EXISTING LAYOUTS

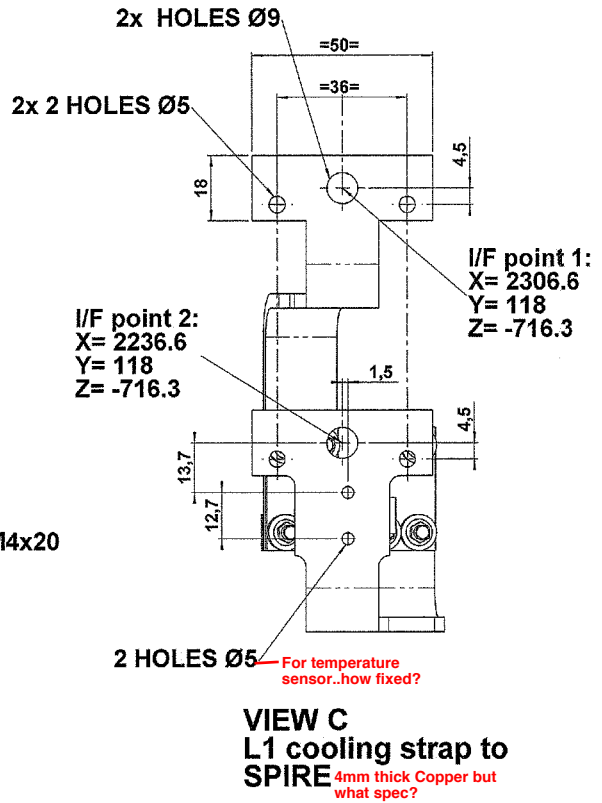
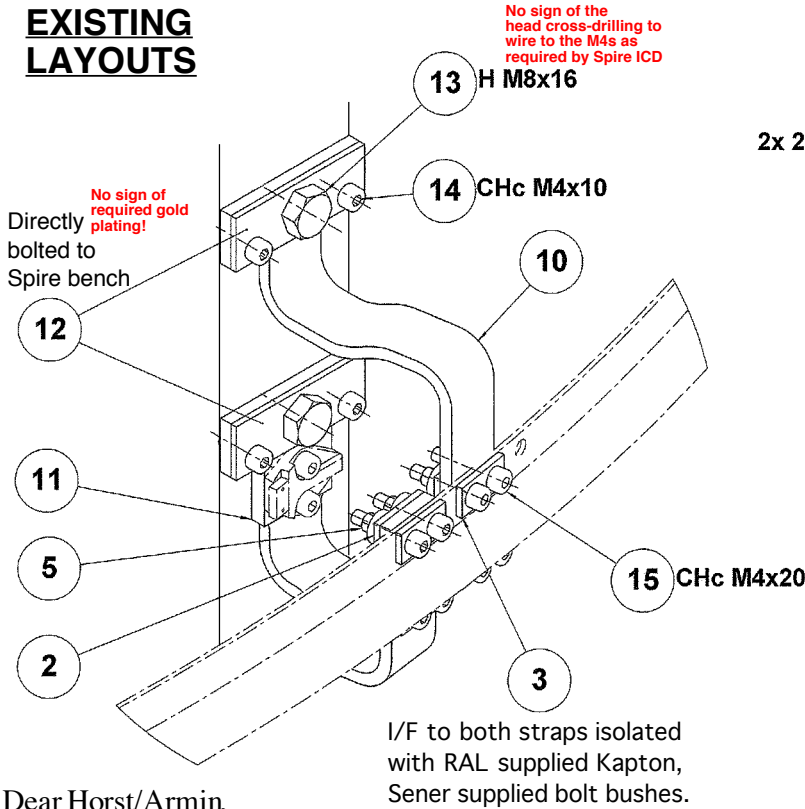
Given all these considerations we proposed to rework the L1 Spire interface slightly. The Kapton between straps and boil-off pipe would not be used and a 2mm thick plate would be bonded to the Spire optical bench.

This plate could be either aluminium or copper, copper suiting copper straps or aluminium suiting aluminium straps. The copper plate would be slotted in its reverse (as shown) to minimise stress on the bench but this would still leave an aluminium to copper joint at the pipe end.

Please could Astrium give a reaction to this note, and particularly a preference for plate material, before Spire raises an ECR.
